Access Compliance Report Public Rights-of-Way (Curb Ramps)

Main Street: BOSTONIAN_DR Cross Street: MONTECITO_RD Location: SE

ADA ID: RPRK211215134208 Ramp Type: Type 4 - Parallel Initial Pass/Fail: Fail Overall Compliance: No Severity Score: 2

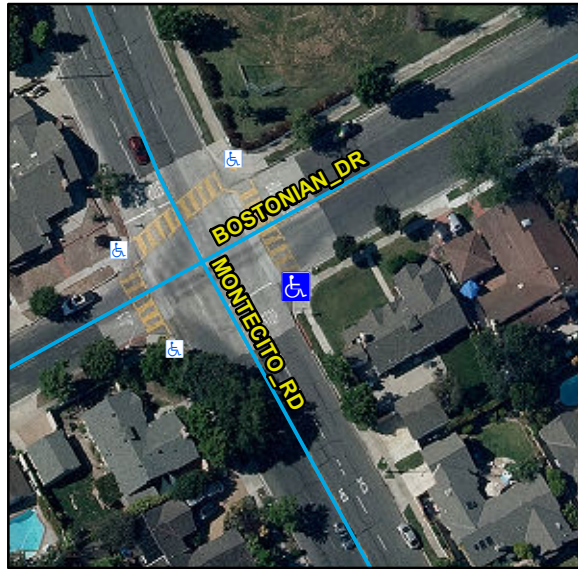
Compliance	Description	Data	Compliance	Description	Data
N/A	Ramp Length LT (in)	109	N/A	Ramp Length RT (in)	98
Yes	Ramp Width LT (in)	92	Yes	Ramp Width RT (in)	92
Yes	Ramp Run Slope LT (%)	7.9	Yes	Ramp Run Slope RT (%)	4
No	Ramp Cross Slope LT (%)	4.6	No	Ramp Cross Slope RT (%)	4.3
N/A	Landing Present	N/A	N/A	DWS Provided	N/A
N/A	Landing Length (in)	N/A	N/A	DWS Contrast	N/A
N/A	Landing Width (in)	N/A	N/A	DWS Length (in)	N/A
N/A	Landing Run Slope (%)	N/A	N/A	DWS Full Width	N/A
N/A	Landing Cross Slope (%)	N/A		DWS Offset Type	N/A
N/A	Landing Movement Obstructed?	N/A	N/A	DWS Offset Left (in)	N/A
	Landing Movement Type	N/A	N/A	DWS Offset Right (in)	N/A
N/A	Landing Shared	N/A			
N/A	Clear Space	Yes			
N/A	Clear Space To Crosswalk (in)	N/A			
N/A	Marked Crosswalk 1	Yes	N/A	Marked Crosswalk 2	No
	Crossing 1 Direction	N		Crossing 2 Direction	W
	Marked Crosswalk 1 Width (in)	144		Marked Crosswalk 2 Width (in)	N/A
N/A	Ramp Inside Crosswalk 1	Yes	N/A	Ramp Inside Crosswalk 2	N/A

Remove & Replace Curb Ramp With Two New Directional Ramps or Equivalent.

R304.5.3, STD 1115
